## Almonry Development Working Group

## Notes from a videoconference on 22 July 2020

## Other toilet provision

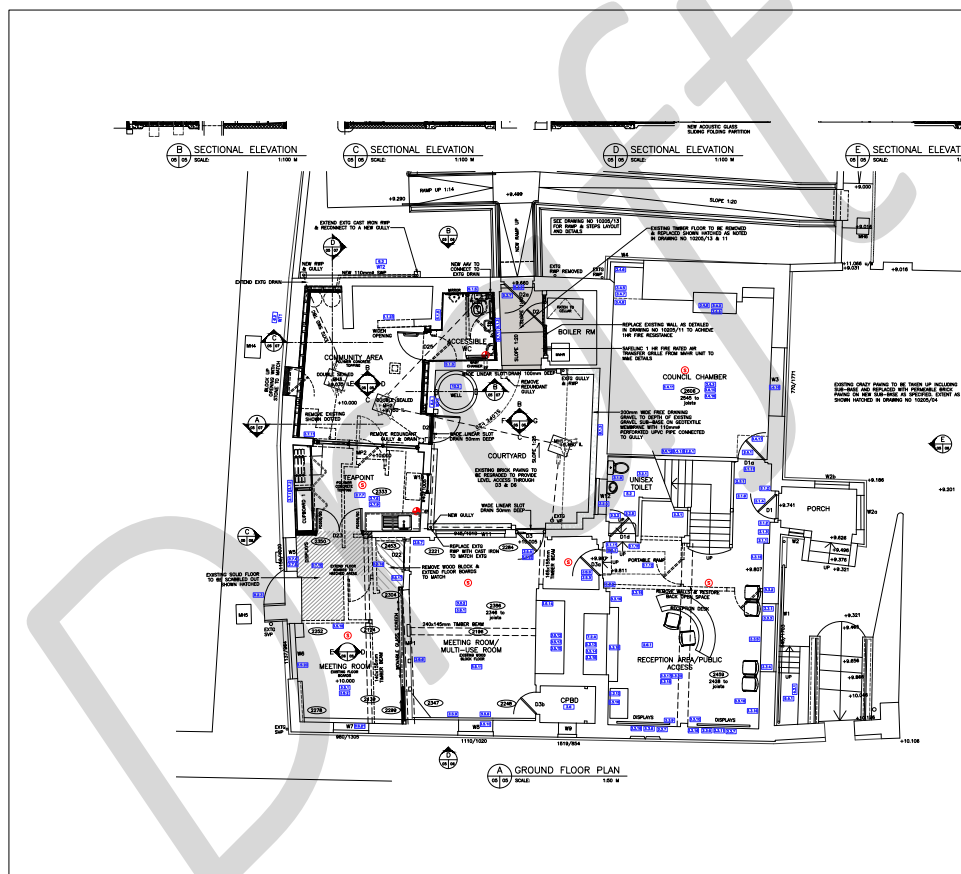
In order to ensure adequate provision for when the site is being used to capacity, it had been agreed that the Working Group would recommend to Council that the outside toilet is given a face-lift to provide two basic WC cubicles. This facility would then also be available for the use of visitors to the garden and the Museum. However, SG now believes that the three toilets (two on the ground floor and one on the first floor) should be sufficient. Council may decide to undertake a basic face-lift of the outside toilet within the current works or leave it for a later phase.

## Ramped approach from front garden to existing entrance

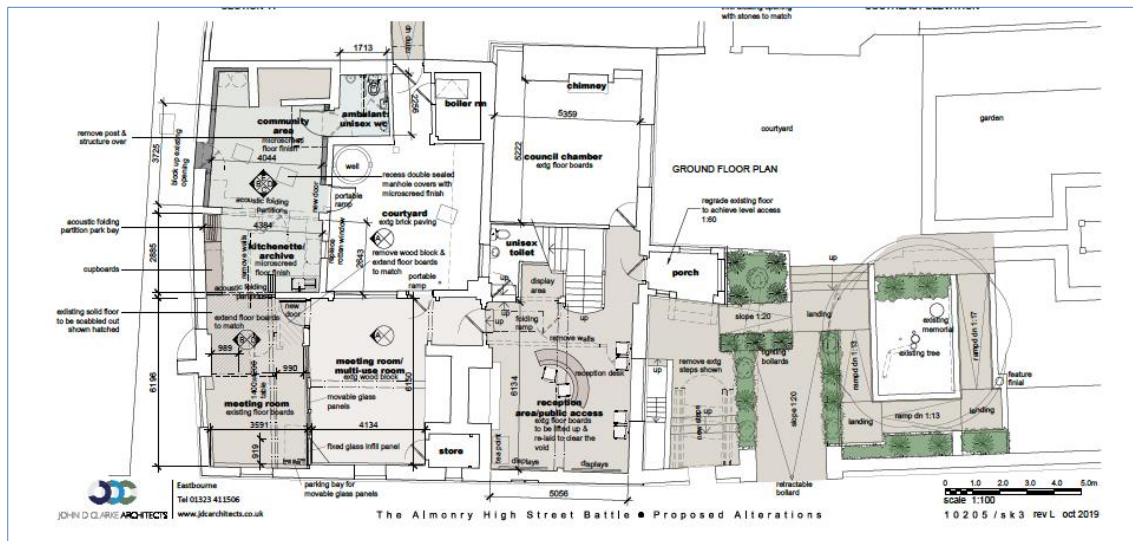
This design was rejected by Council in 2019.

## Ramped approach for High Street Gate to existing entrance

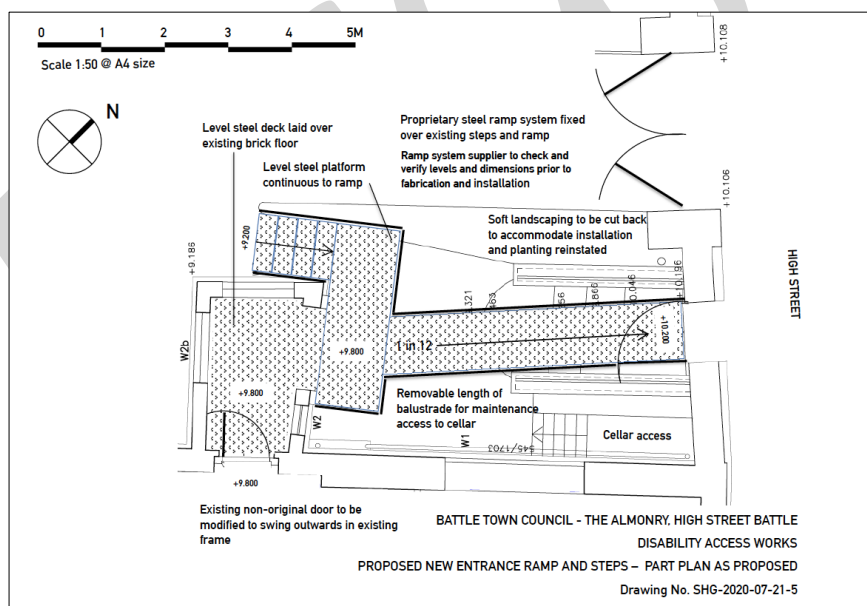
The 1 in 12 ramp is just acceptable. Visitors needing level access will need to go back to the High Street and use the driveway to access the Museum from The Almonry. Visitors unable to negotiate a slope will not have stepped access from the High Street, although there are steps from The Almonry to the sloping driveway.

## Platform lift behind porch

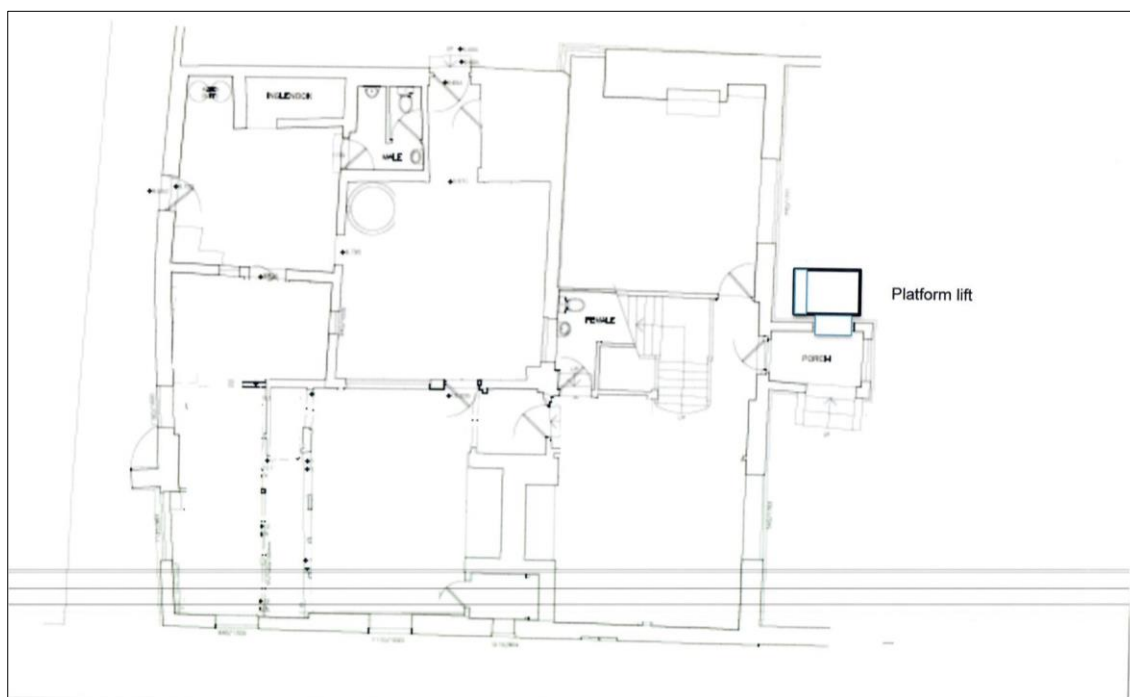
This solution had previously been discounted as unfeasible, partly due to the surface and steepness of the driveway from the High Street. However, SG will draw up a plan to raise the level of the porch floor, re-hang the main door to open outwards and install an enclosed lift.

The removal of the partition in the hall by the stairs, as in the plans that have already received Listed Building consent, would not only give a feeling of space, but, more importantly, add light for visually impaired people.

The Working Group recommends the lift option to Council.
